**NPDES PERMIT FACT SHEET
ADDENDUM**

Application No. PA0008664
APS ID 551679
Authorization ID 1216622

Applicant Name	<u>Hunlock Creek Generating LLC</u>	Facility Name	<u>Hunlock Creek Energy Center</u>
Applicant Address	<u>390 US Route 11</u> <u>Hunlock Creek, PA 18621</u>	Facility Address	<u>390 US Route 11</u> <u>Hunlock Creek, PA 18621</u>
Applicant Contact	<u>Jeff Steeber</u>	Facility Contact	<u>Jeff Steeber</u>
Applicant Phone	<u>(570) 542-2790</u>	Facility Phone	<u>(570) 542-2790</u>
Client ID	<u>72983</u>	Site ID	<u>264295</u>
SIC Code	<u>4911</u>	Municipality	<u>Hunlock Township</u>
SIC Description	<u>Trans. & Utilities - Electric Services</u>	County	<u>Luzerne</u>
Date Published in PA Bulletin	<u>January 18, 2025</u>	EPA Waived?	<u>Yes</u>
Comment Period End Date	<u>February 17, 2025</u>	If No, Reason	<u>-</u>
Purpose of Application	<u>Renewal and amendment of NPDES permit.</u>

Figure 3. Monthly Average Effluent TRC Concentrations

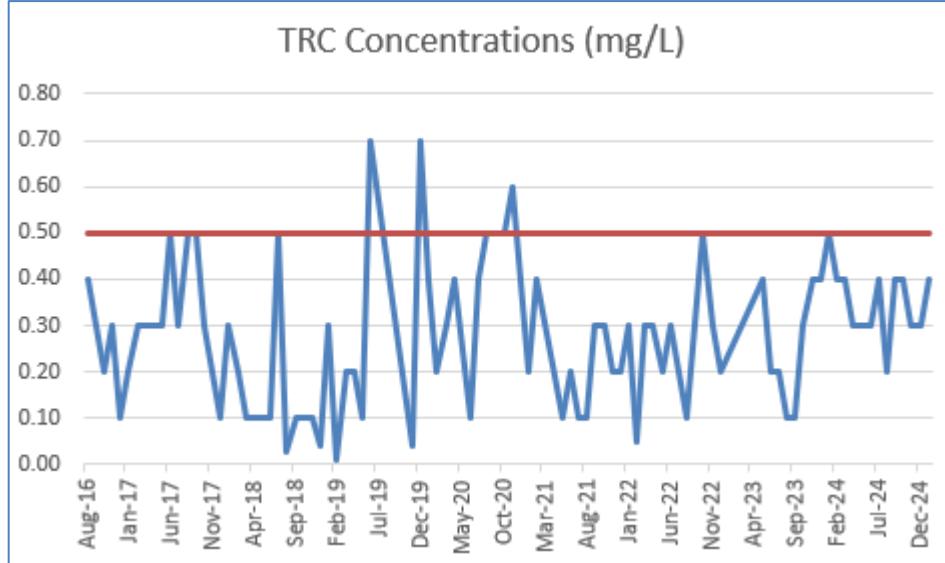
"Hunlock notes that the Average Monthly discharge concentration for Total Residual Chlorine (TRC) has been reduced at Outfall 004 from 1.0 mg/L to 0.5 mg/L and the Instantaneous Maximum discharge concentration for TRC has been reduced from 2.0 to 1.1 mg/L.

The Outfall 004 discharge includes an average flow of 0.00357 MGD of treated sanitary sewage effluent from a small packaged treatment system, which, as PADEP notes in the Fact Sheet on page 5, is a minor discharge when compared to the Q1-101 River flow of 883 cubic feet per second (cfs). The Facility receives Potable Water supplied from PA American that frequently exceeds the draft Instantaneous Maximum discharge TRC concentration. During low-flow periods, dilute water (i.e., from sinks, etc.) would potentially contain 'pass-through' concentrations of TRC that would exceed the draft TRC limitations. Hunlock employs a chlorination system to properly disinfect all sanitary wastewater prior to discharge through Outfall 004.

Of note, the 1.1 mg/L Instantaneous Maximum discharge TRC concentration does not match PADEP's SOP No. BCW-PMT-032 Establishing Effluent Limitations for Individual Industrial Permits, which states an Instantaneous Maximum limit of 1.6

mg/L is normally considered Best Professional Judgement. Hunlock requests clarification from PADEP on the basis for the more stringent limit of 1.1 mg/L TRC at Outfall 004.

Further, 25 PA Code 92a.48 allows for PADEP to develop facility-specific Best Available Technology (BAT) limits for TRC in cases where the EPA has not promulgated a National ELG, as for the treated effluent at Outfall 004. In consideration of the existing sanitary treatment equipment and facilities, the influent TRC concentrations in the potable water supply system, current and future disinfection requirements, and the substantial difference between the Outfall 004 discharge flow and Susquehanna River flow, Hunlock respectfully requests that the current Average Monthly TRC discharge concentration of 1.0 mg/L and Instantaneous Maximum discharge concentration of 2.0 mg/L be maintained in the renewed NPDES permit."

The 0.5 mg/L monthly average TRC limitation is considered a BAT limitation for similar package sewage treatment plants. These limitations are included in NPDES permits for other small facilities that discharge to large receiving waters. Across the state, permit application reviewers utilize the TRC calculation spreadsheet to calculate average monthly and IMAX limitations for sewage discharges. The TRC calculation spreadsheet and all other modeling programs used by permit application reviewers are available to the public on DEP's website for download. The 1.6 mg/L IMAX is the technology-based limitation recommended when a facility is required to sample daily. A 1.1 mg/L IMAX is recommended when a facility samples for TRC on a weekly basis. See the images below of the TRC calculation spreadsheet results for both scenarios:

It's understood that the public water contains residual chlorine, however, other package sewage treatment plants subject to the BAT limitations also treat sewage with a similar water supply. The graph below shows the new monthly average limitation (0.5 mg/L) as it relates to the eDMR reported monthly average TRC concentrations at Outfall 004 since August 2016:

It appears the permittee can meet the new TRC limitations under current operations and would be able to consistently meet the limitations with only minor process adjustments needed (if any). eDMR data shows the permittee has consistently met their Fecal Coliform limitations over the same timeframe.

The effective date of the new TRC limitations is revised to one year after the permit effective date to allow for time to make any needed process adjustments. The existing limitations will be in effect for the first year of permit coverage.
